Subject: Contract Amendment for Design Services of the Park at Perimeter Center East

Contract Amendment with CHA Consulting for additional design services for the water feature at the park at Perimeter Center East

EXTRA WORK AUTHORIZATION

THE PROJECT: The Park at Perimeter Center East

C-1

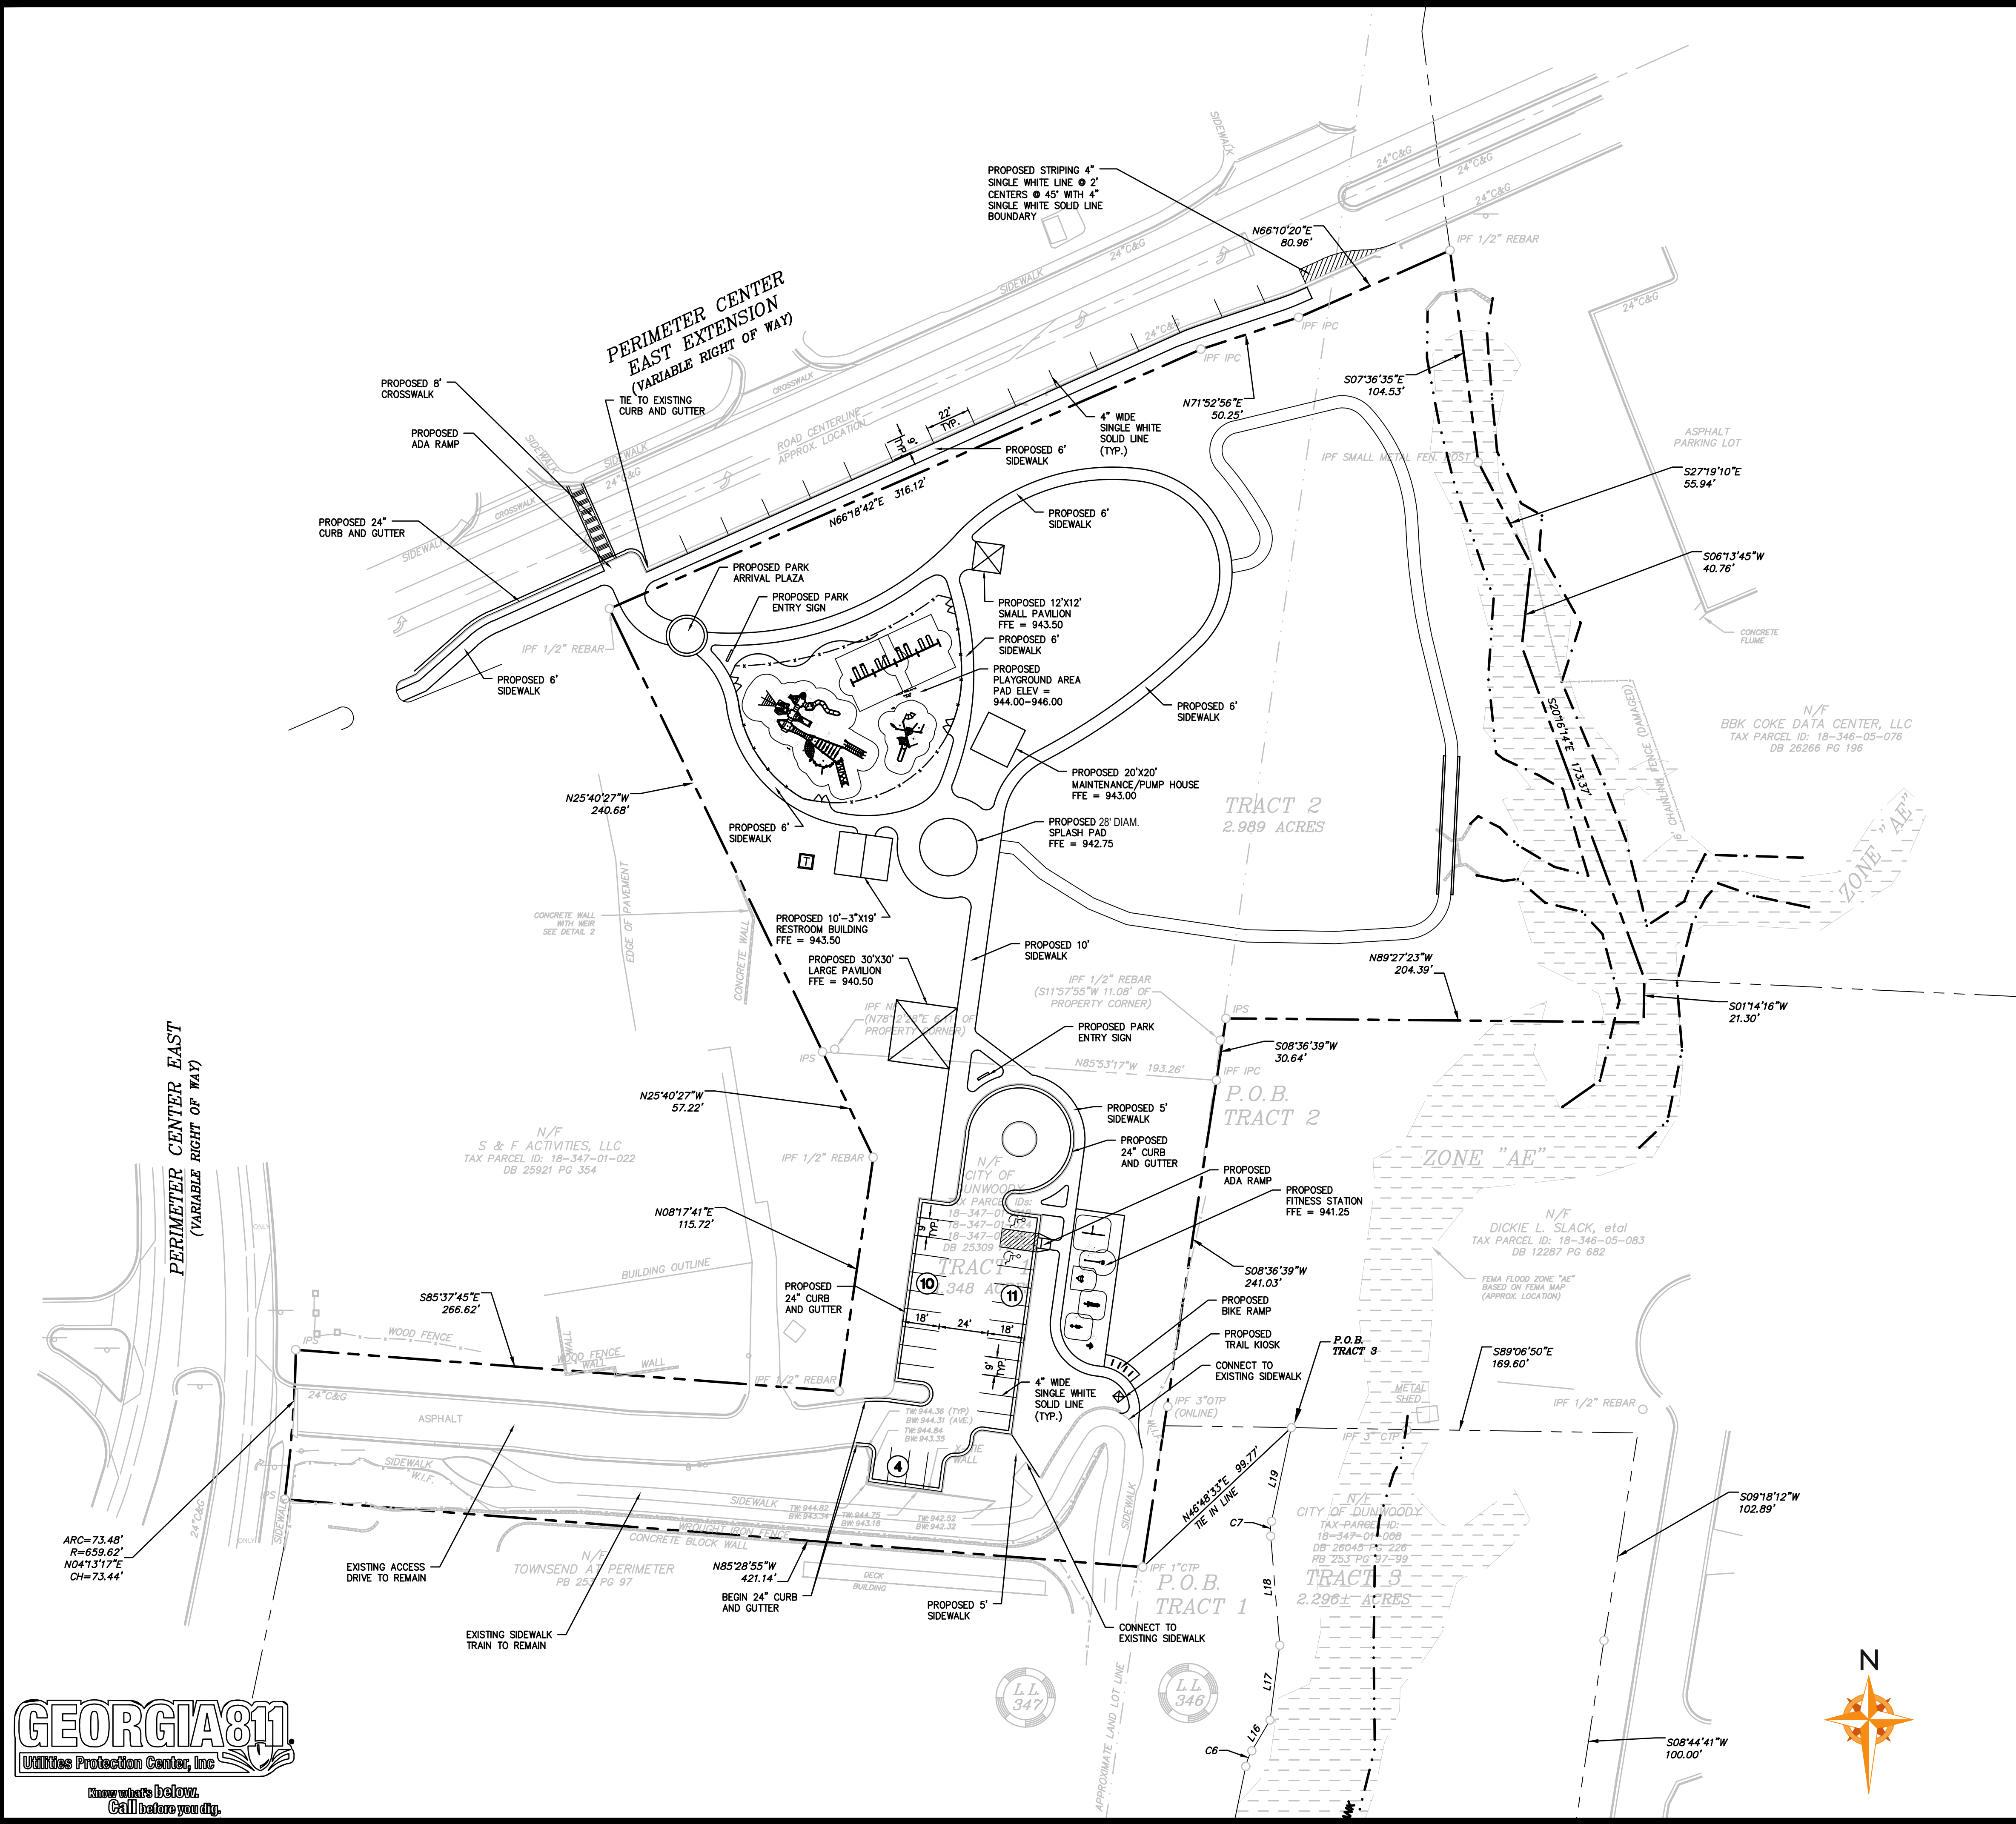
At the September 24th Council meeting, Councilman Lambert had questions about the placement of the pump house. Staff confirmed with the consultant that the pump house was placed in the location shown for the following reasons:

1. Eliminate conflict with the proposed electrical transformer location
2. There is an existing sanitary sewer manhole and sewer line in the area west of the restroom building that would make placement of the building in that area a little tight, and
3. The ability to screen the pump house with vegetation in the proposed location

The consultant has revisited the site plan and think that they might be able to fit the pump house next to the restroom if that is the preferred location. They will need to verify that the existing sanitary sewer line is private and does not have an easement and relocate the electrical transformer.
